ADDENDUM

PROJECT: Cherry County Hospital
Patient Wing - Toilet Room Renovation
Valentine, Nebraska

AD-3

PROJECT #: 11-0148

Drawing #
 P-103

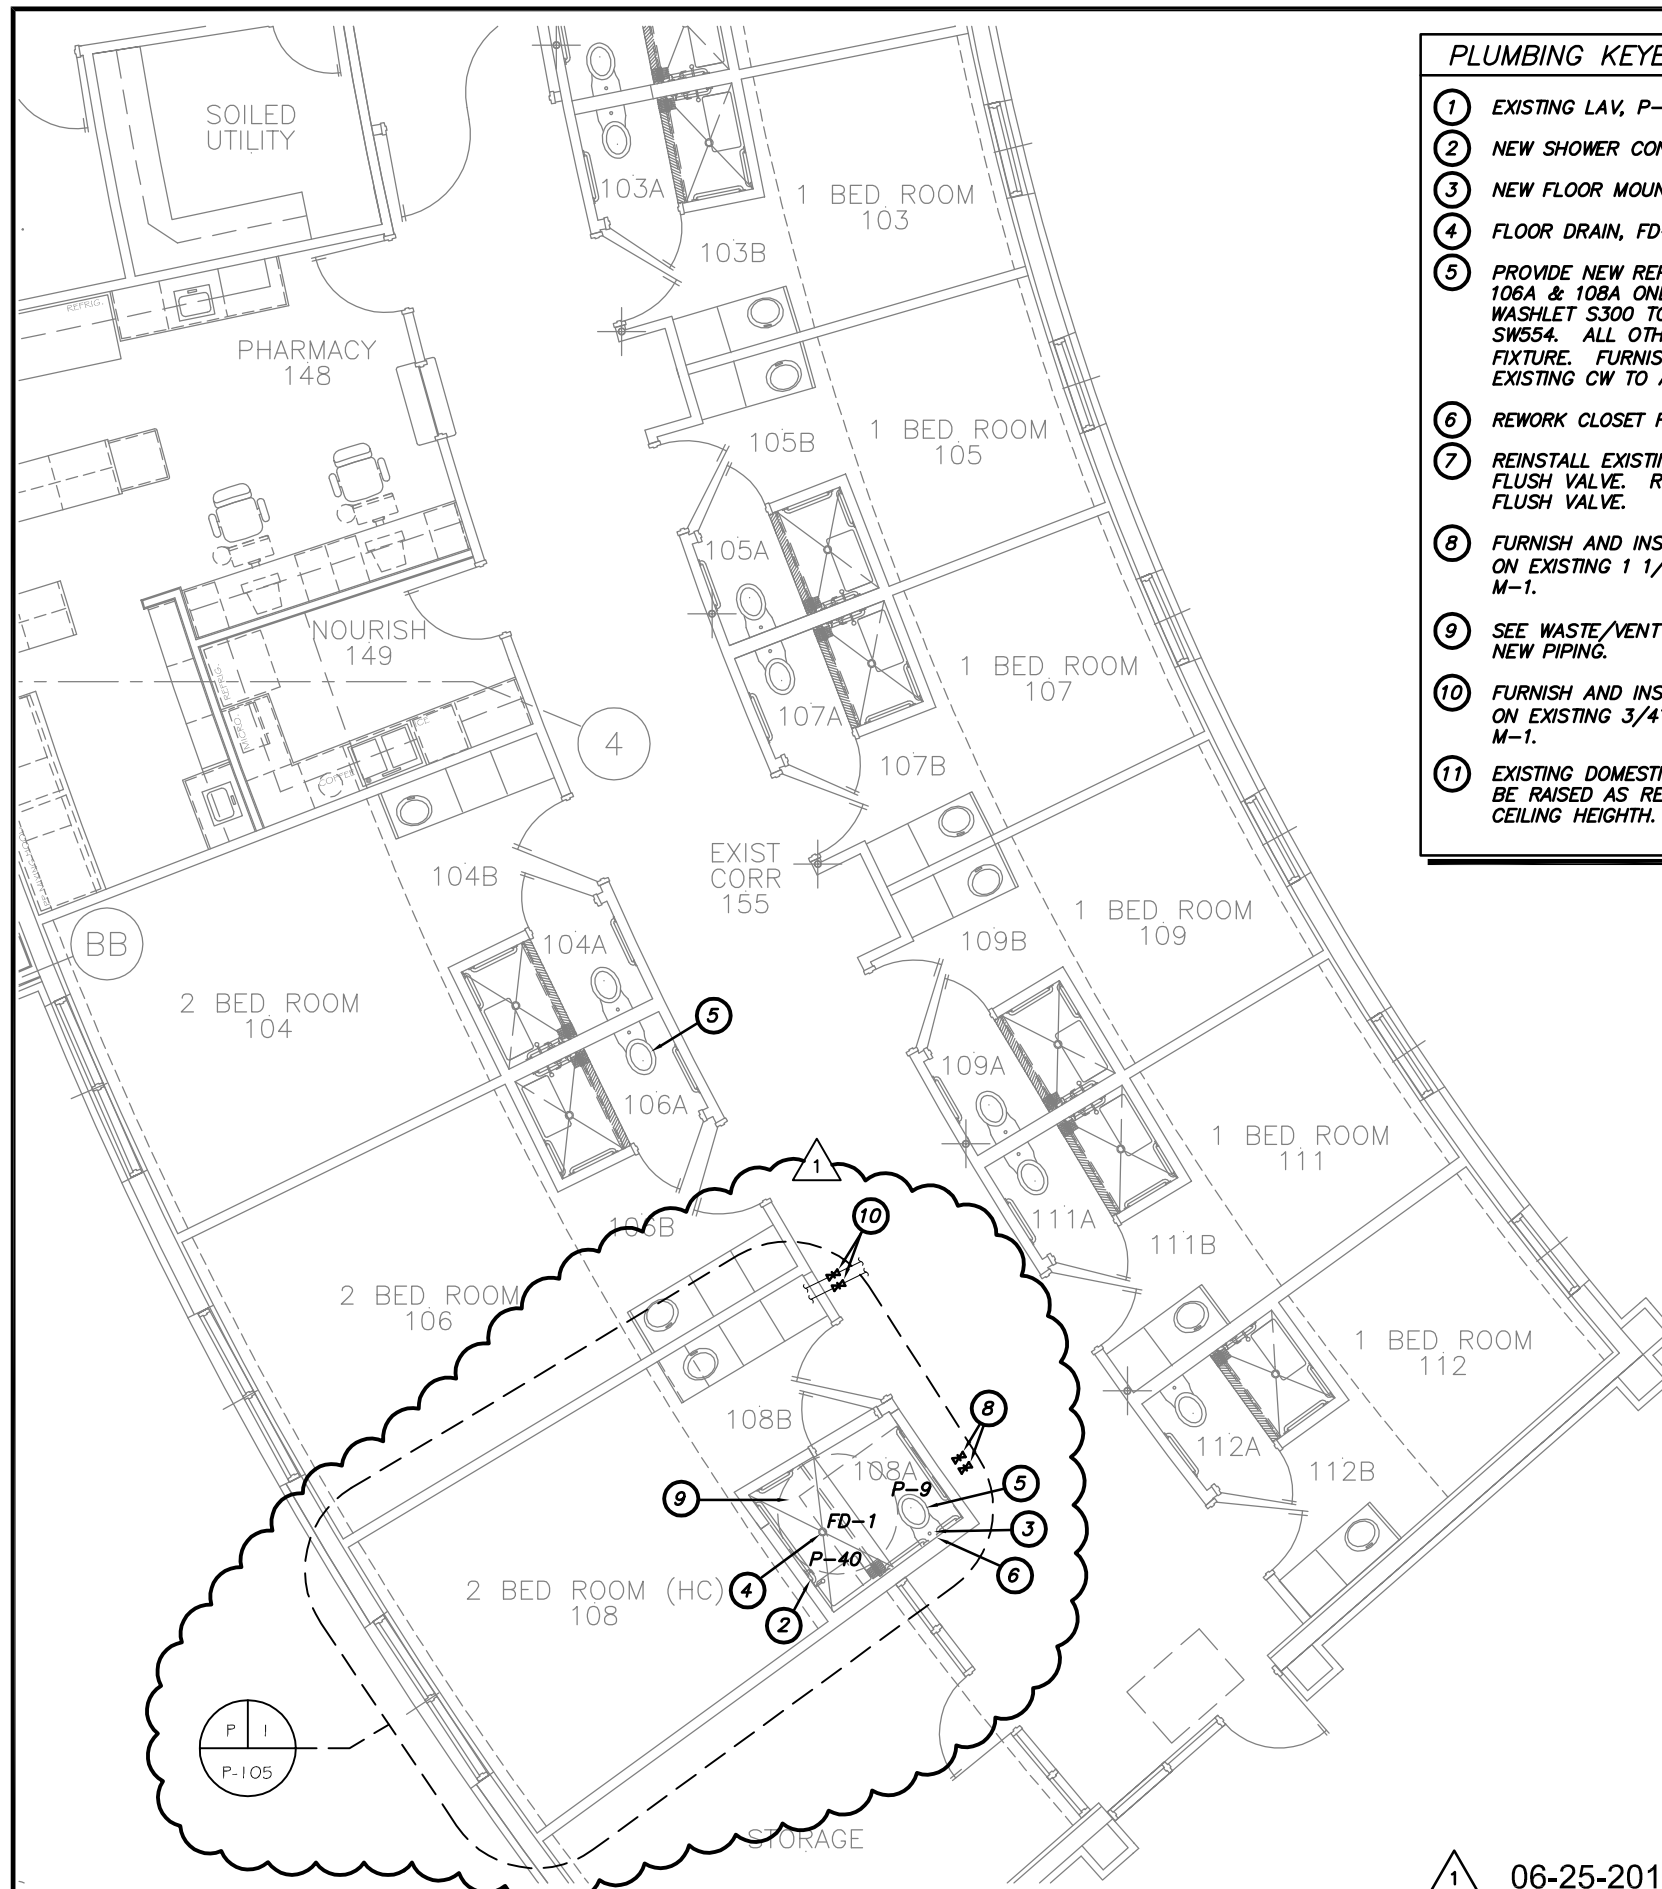
In reference to Sheet P103, below grade soil and waste shall be either specified cast iron or Schedule 40 PVC with drainage fittings and solvent welded joints. Plumbing contractor shall provide acceptable transitions between materials which comply with Applicable Codes.
